Access Compliance Report Public Rights-of-Way (Curb Ramps)

Main Street: CAMBERA_LN Cross Street: BIMINI_DR Location: N

ADA ID: RPRK211228134528 Ramp Type: Type 1 - Perpendicular Diagonal Initial Pass/Fail: Pass Overall Compliance: No Severity Score: 16

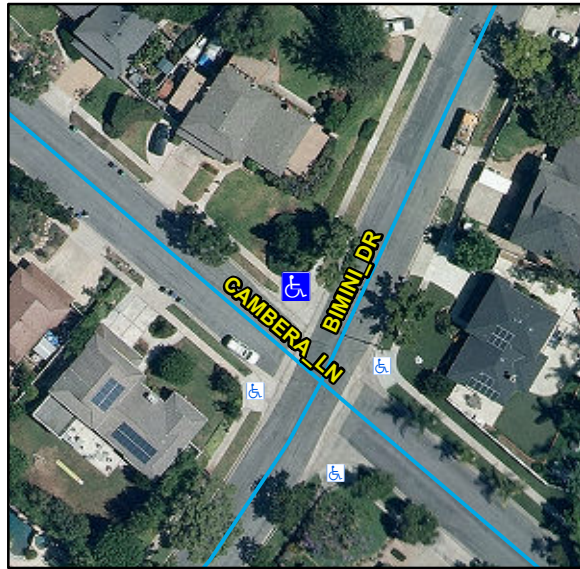
Remove & Replace Curb Ramp With Two New Directional Ramps or Equivalent.

R304.2.1, R305, STD 1115
